**SITE PLAN REVIEW TECHNICAL ADVISORY COMMITTEE  
PORTSMOUTH, NEW HAMPSHIRE**

**May 4, 2021**

**AGENDA**

**SITE PLAN**

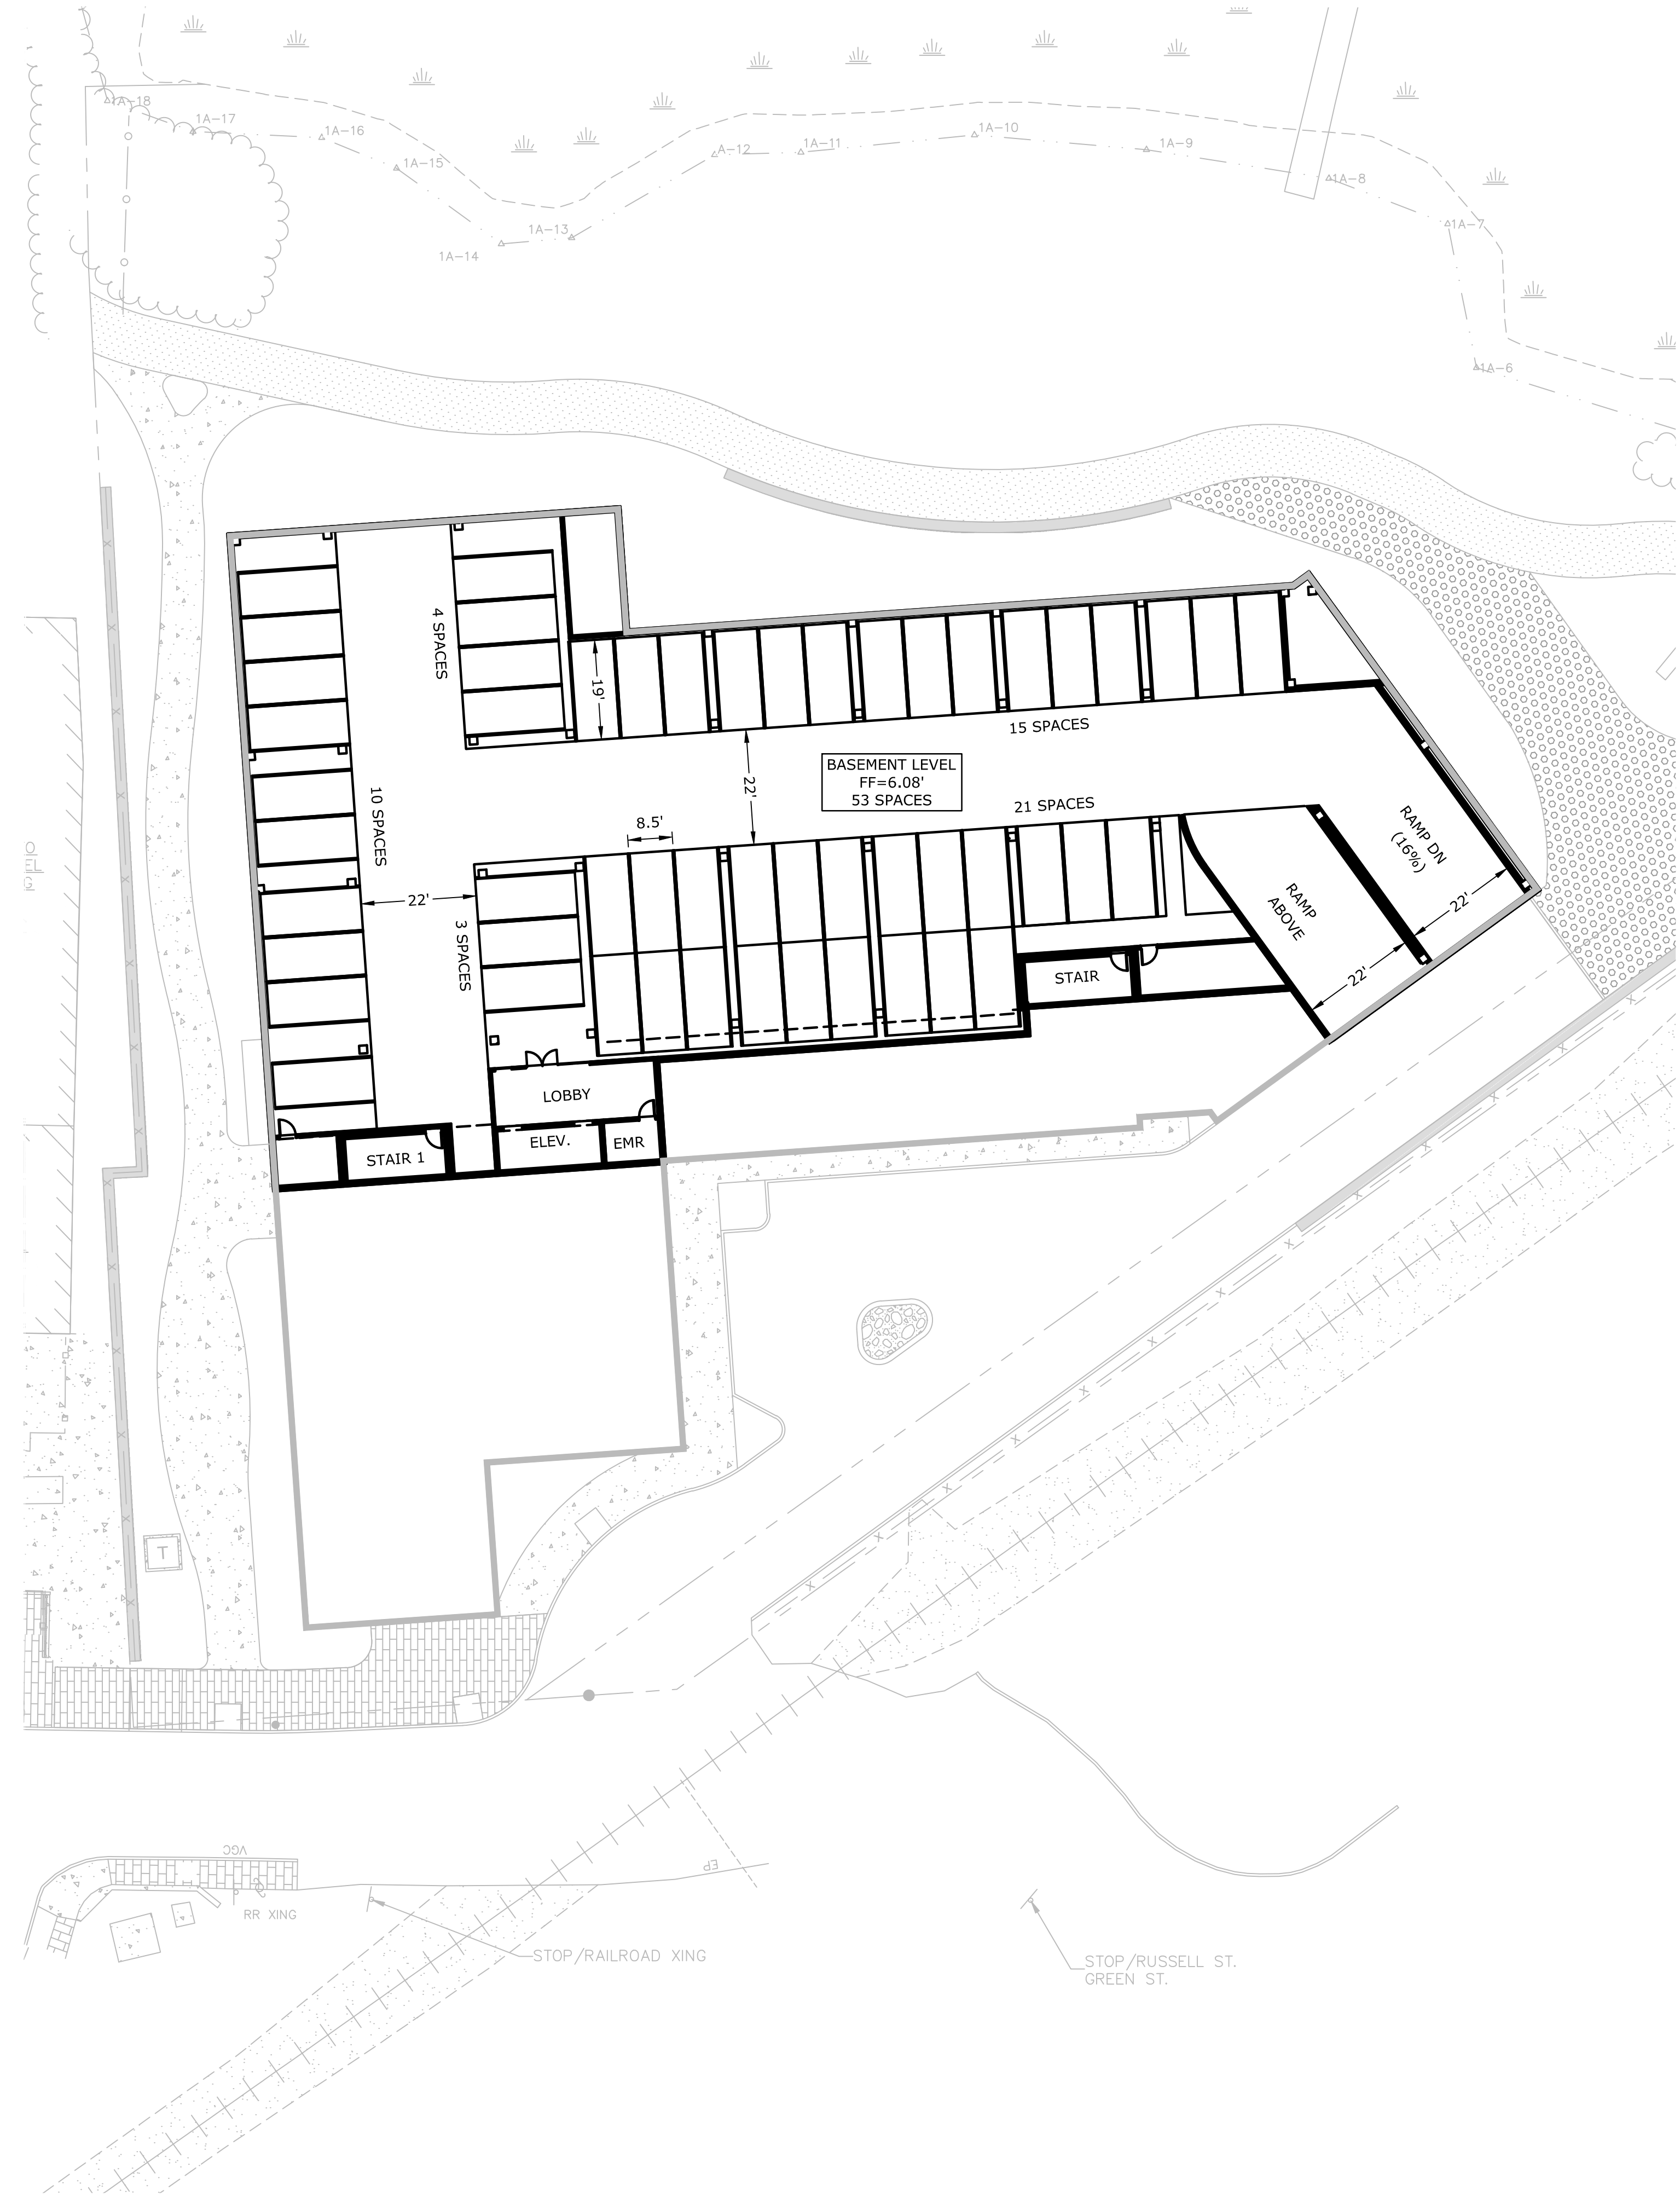
- Mr. Crimmins confirmed that they would provide additional documentation.
- Footnote #2 in the development standards chart on Sheet C-102 should reference Section 10.5A46.10 instead of Section 10.5A43.43.

- Min. Front Lot Line Buildout (FLLB) compliance needs to be verified.
- Sheet C-102 Development standards footnote (2) needs to be reassigned to reflect the Overlay Incentive District requirements as Section 10.5A43.43 does not apply to this project.

3	Footnote #2 in the development standards chart on Sheet C-102 should reference Section 10.5A46.10 instead of Section 10.5A43.43.	Footnote #2 in the development standards chart has been revised to reference Section 10.5A46.10 instead of Section 10.5A43.43.	C-102
4	As you know, these properties front on multiple height districts, please provide more details on how your base building height was calculated.	The final building height and footprint will comply with the City's zoning ordinance. A detailed grade plane exhibit and building height exhibit have been provided showing average grade plane and proposed building heights.	Grade Plane Exhibit & A3.01
5	Footnote #3 in the development standards chart should reference Section 10.5A46.10.	Footnote #3 in the development standards chart has been revised reference Section 10.5A46.10.	C-102
6	The parking demand analysis letter provided references the ability to share parking spaces with 145 Maplewood Ave office building. Is there an existing agreement in place?	Per Article 11 Section 10.1112.62 the shared parking arrangement shall be secured by a covenant acceptable to the City and recorded at the Rockingham County Registry of Deeds (RCRD). The applicant understands that should the Planning Board grant the shared parking CUP, as a condition of approval the applicant will be required to record the agreement. The applicant has shared the shared parking analysis with the Kane Company / 145 Maplewood LLC and they support the analysis and have committed to entering into a shared parking agreement to be secured with a covenant acceptable to the City and recorded at the RCRD. The enclosed CUP request has been revised to indicate this as well.	CUP Letter
